**SUBJECT: INDEPENDENT CONFIRMATORY SURVEY SUMMARY AND
RESULTS FOR THE U.S. ENVIRONMENTAL PROTECTION AGENCY
HARMON AVENUE COMPLEX ON THE UNIVERSITY OF NEVADA,
LAS VEGAS CAMPUS
LAS VEGAS, NEVADA
[RFTA No. 16-014, Docket No. 03006981]
DCN 5297-SR-01-0**

**INDEPENDENT CONFIRMATORY SURVEY
SUMMARY AND RESULTS FOR THE U.S.
ENVIRONMENTAL PROTECTION AGENCY
HARMON AVENUE COMPLEX ON THE
UNIVERSITY OF NEVADA, LAS VEGAS
CAMPUS
LAS VEGAS, NEVADA**

FINAL REPORT

Prepared for the U.S. Nuclear Regulatory Commission

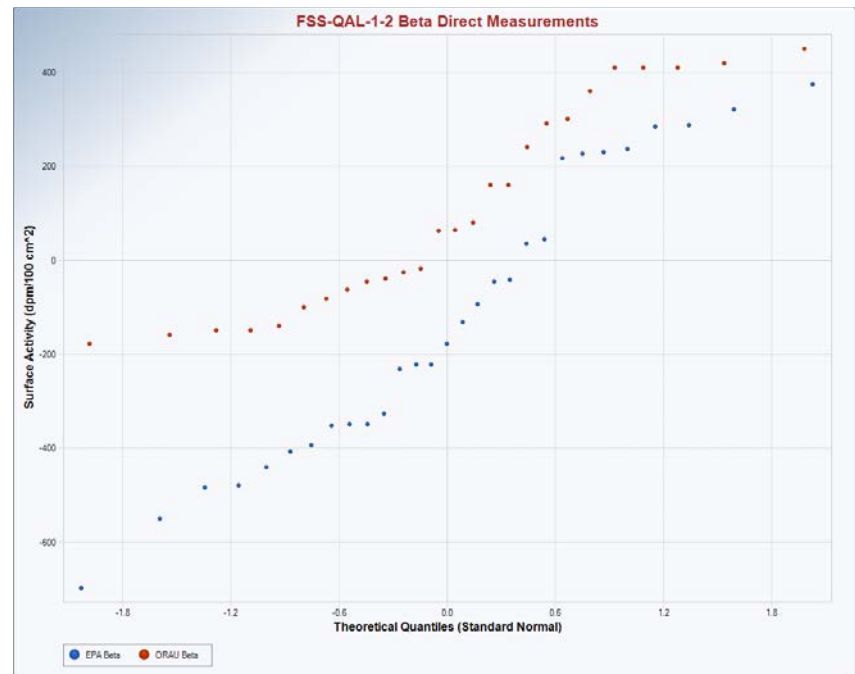
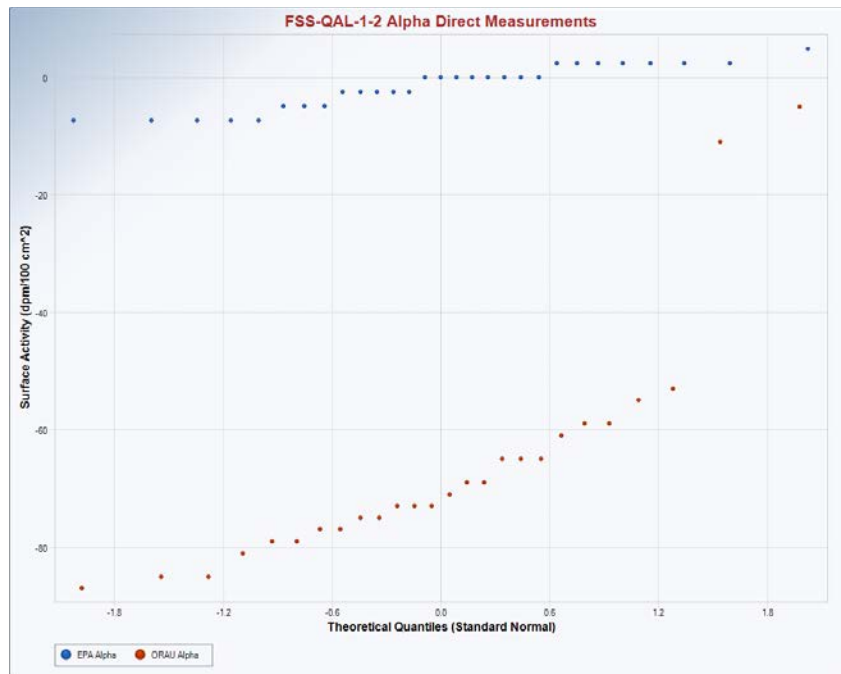
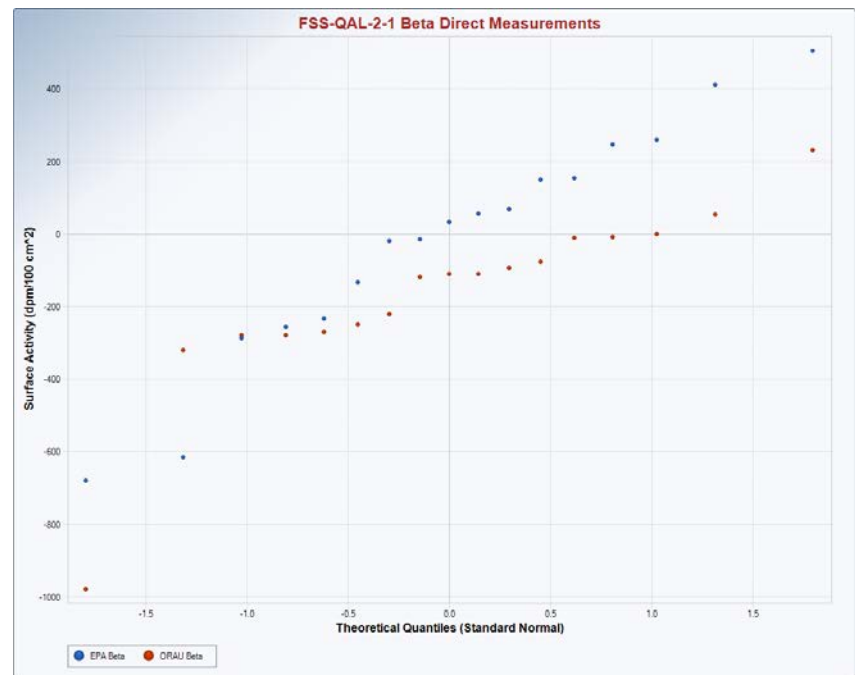
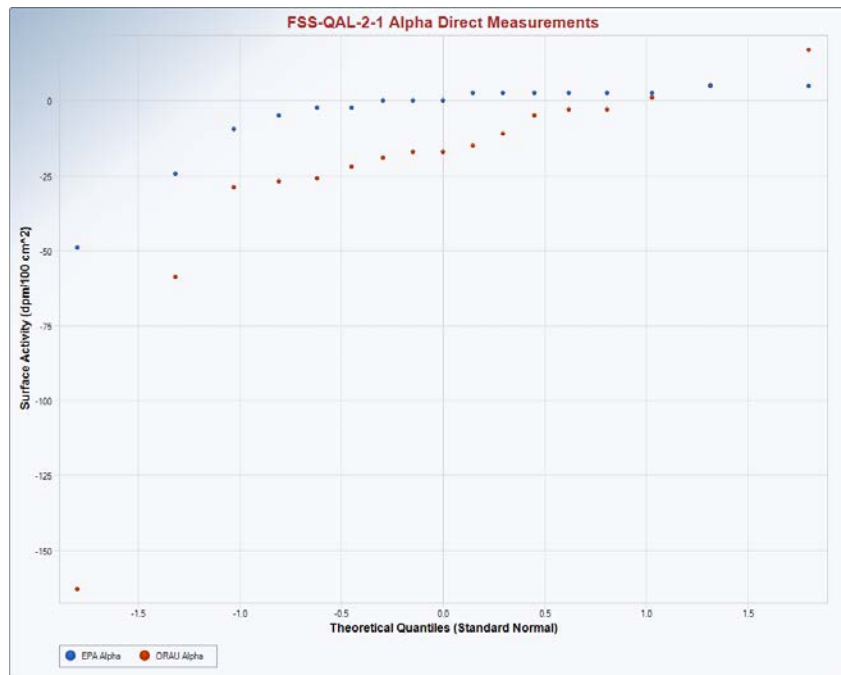
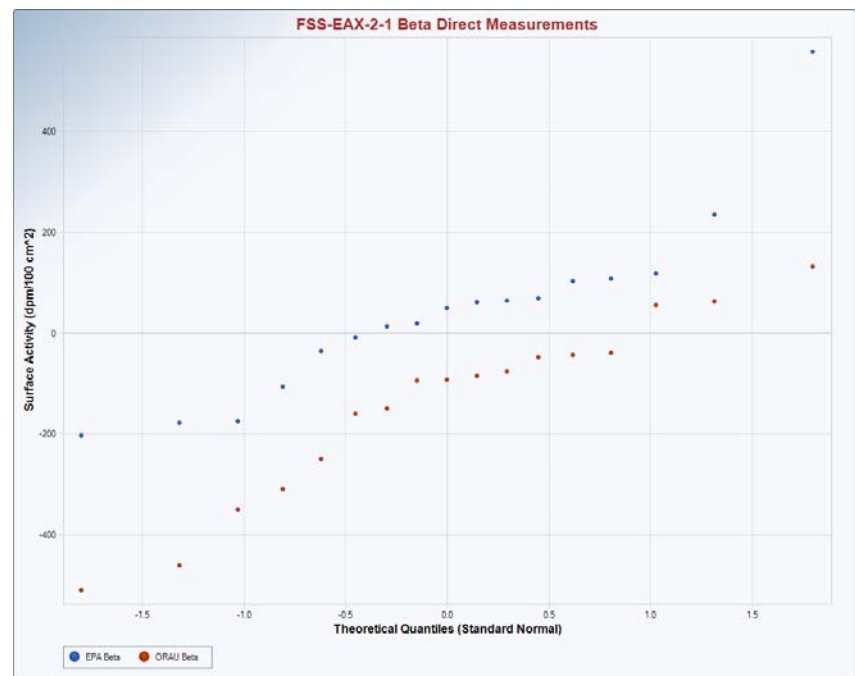
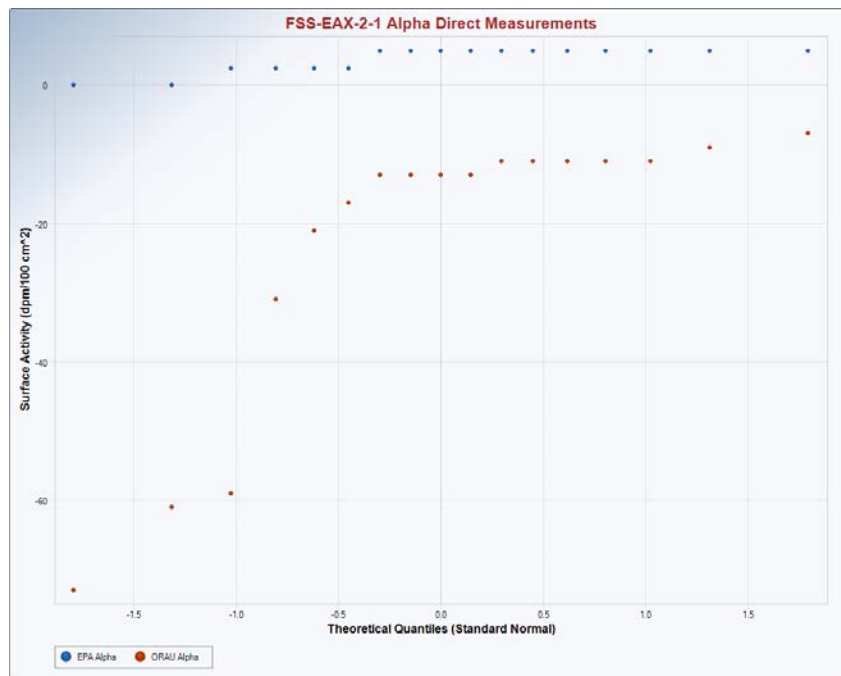
The null hypothesis was rejected for all but one case. Rejecting the null hypothesis indicates that the two data populations are different. The data were also graphed with Q-Q plots (quantile-quantile plot), Figures A6 through A9. The plots show that the licensee's data are biased high compared to ORISE's data (i.e., the licensee is reporting higher activities than ORISE).
